PRE-BID CLARIFICATION FORM (For Contractor's Use)

PROJECT NAME:	Newport Harbor High School Pool Equipment Replacement		
PROJECT NUMBER:	103-21		
TO:	Jonathan Geiszler, Director of Purchasing & Warehouse	EMAIL:	jgeiszler@nmusd.us

DATE:	11/25/2020		
FROM:	Brett Crews, Estimator California Waters	EMAIL:	bcrews@californiawaters.com
DOCUMENT/DIVISION NUMBER:	131105 2.01 Filtration equipment	DRAWING NUMBER:

Drawing Number:	SS7-72-12
-----------------	-----------

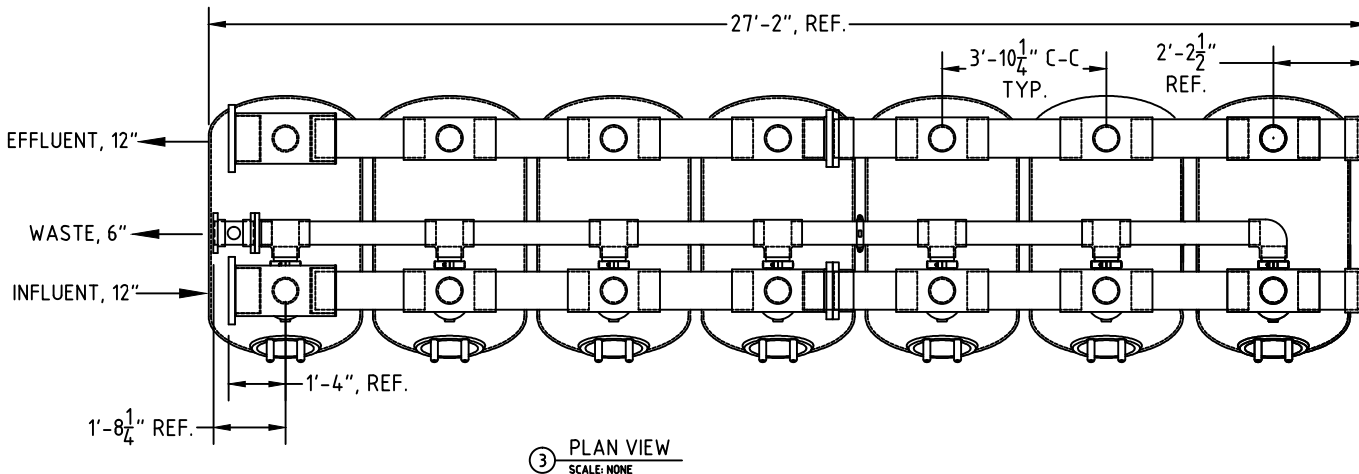
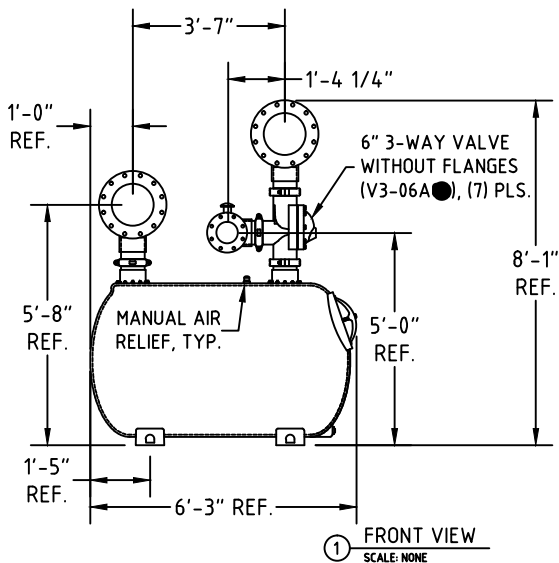
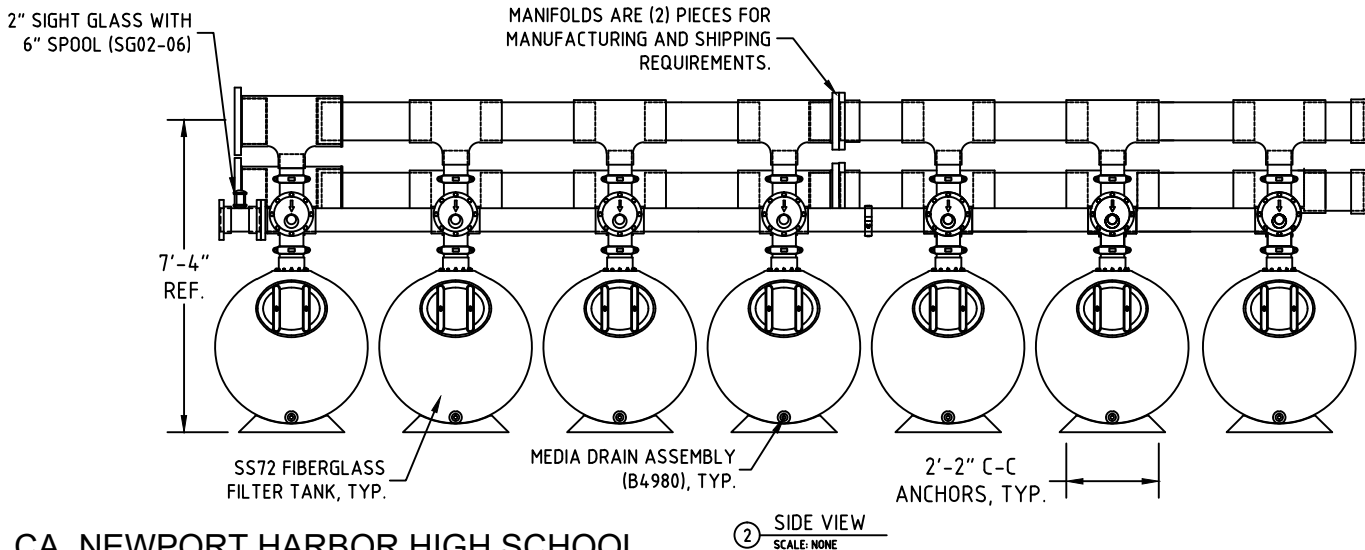
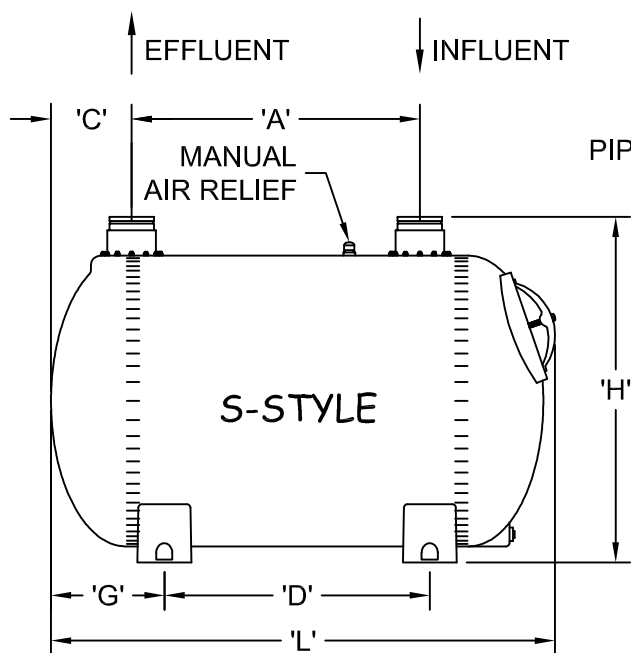
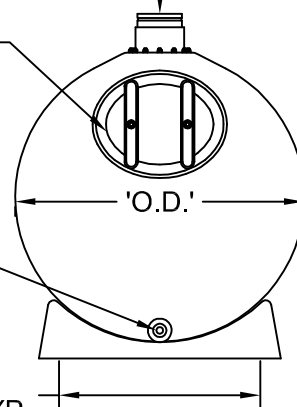
REQUESTED CLARIFICATION:
<p align="center">Would like to submit the attached documentation for Stark filter system by Pentair Aquatic System as an acceptable alternate to the sole source Eko3 noted in the specification.</p>
RESPONSE TO CLARIFICATION:
<p>Contractors may provide a substitute bid in addition to the base bid with associated changes in costs for a Stark Filtration system equal in size and capacity to the specified EKO3 filtration system. Substitute bids received will not be the basis for Contractor selection and Award of Contract.</p> <p>Bernie Rogers, Terracon 11/30/20</p>
